CITY OF ALBUQUERQUE

**RE: Lindo Mexico Restaurant
3937 Coors Blvd NW
Grading and Drainage Plan
Engineer's Stamp Date: 12/5/2025
Hydrology File: G11D067H
Case # HYDR-2025-00436**

Based upon the information provided in your submittal received 12/05/2025, the Grading & Drainage Plans **are not** approved for Building Permit. The following comments need to be addressed for approval of the above referenced project:

PROJECT NAME	PROJECT NO.	DATE	REV.	DESCRIPTION	BY
LINDO MEXICO RESTAURANT 3937 COORS BLVD NW ALBUQUERQUE, NM 87120	25033	DECEMBER 2025			
	DESIGNED BY:	RJF			
	DRAWN BY:	JB			
	CHECKED BY:	RJF			
SHEET TITLE					
GRADING PLAN					
SHEET NO. C-1

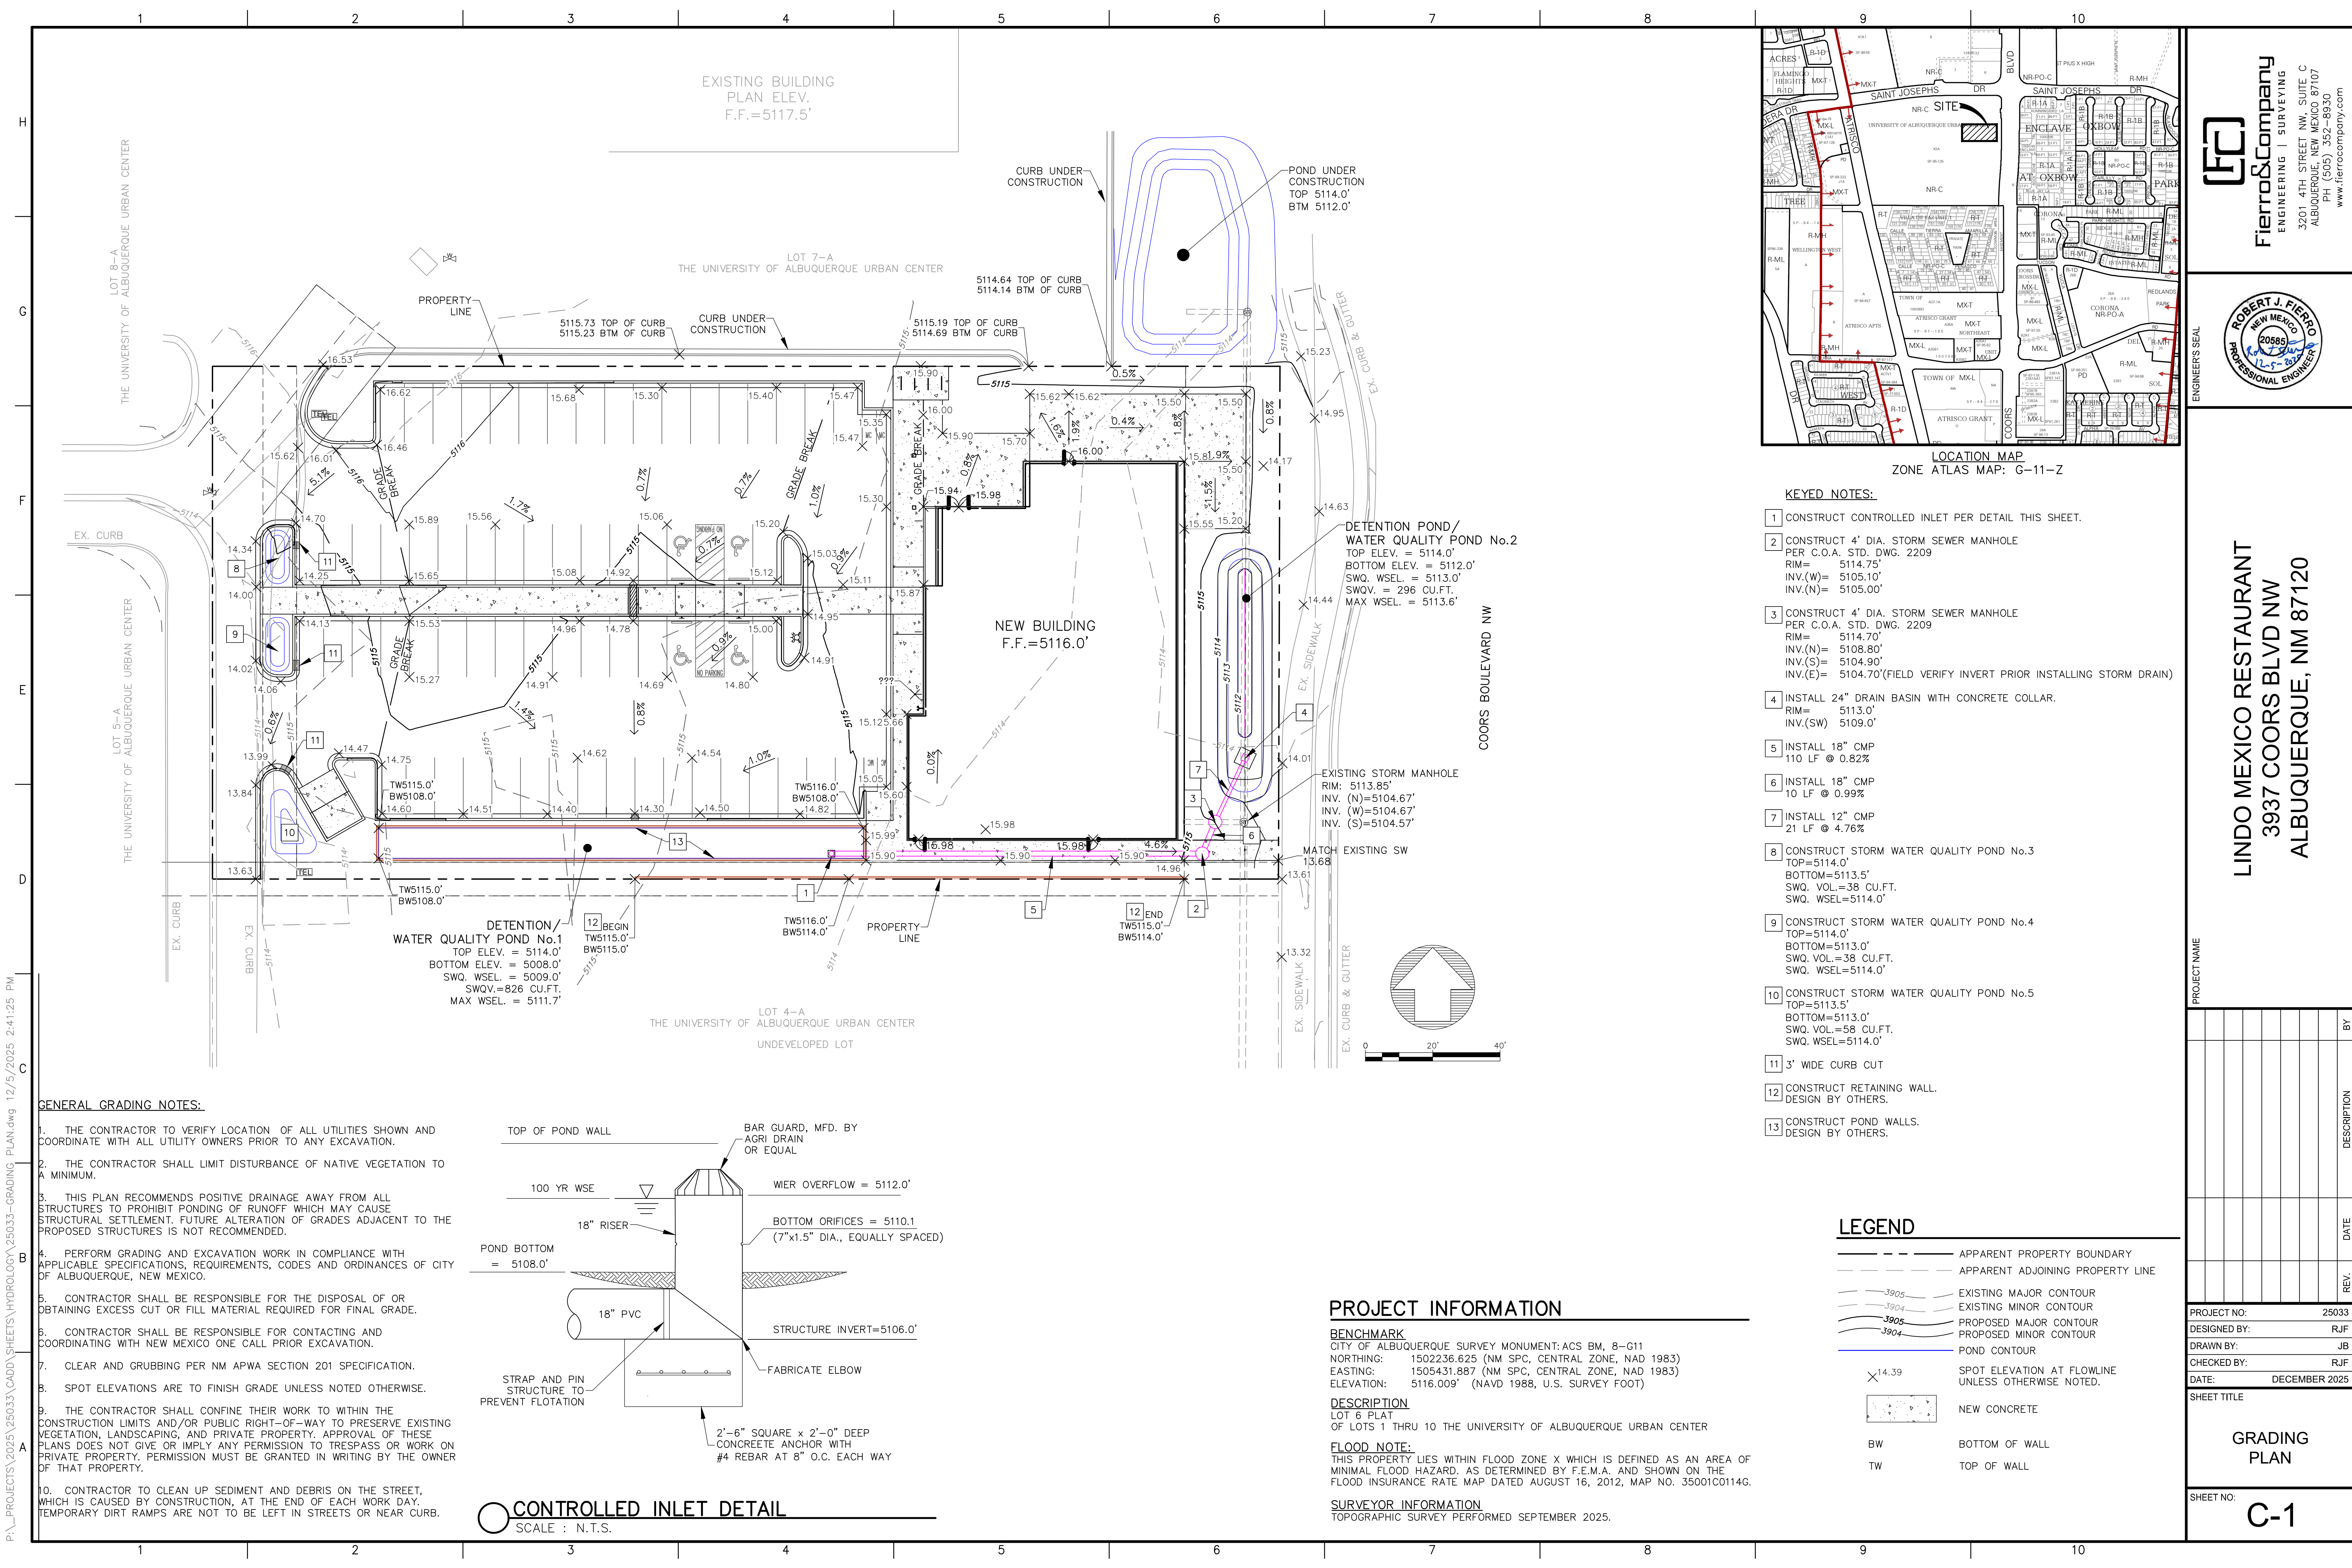
1. For trash enclosures serving food service developments, trash enclosures must demonstrate control of liquids from dumpster areas per DPM by containing runoff from the dumpster area, preventing outside drainage from entering the dumpster area, and discharging to the sanitary sewer. Please show an inlet in the middle and label. "Inlet to be connected to the sanitary sewer. See Utility Plan."
2. Please provide a table showing the Existing and Proposed Land Treatment Types (A, B, C, D) with percentages and areas.
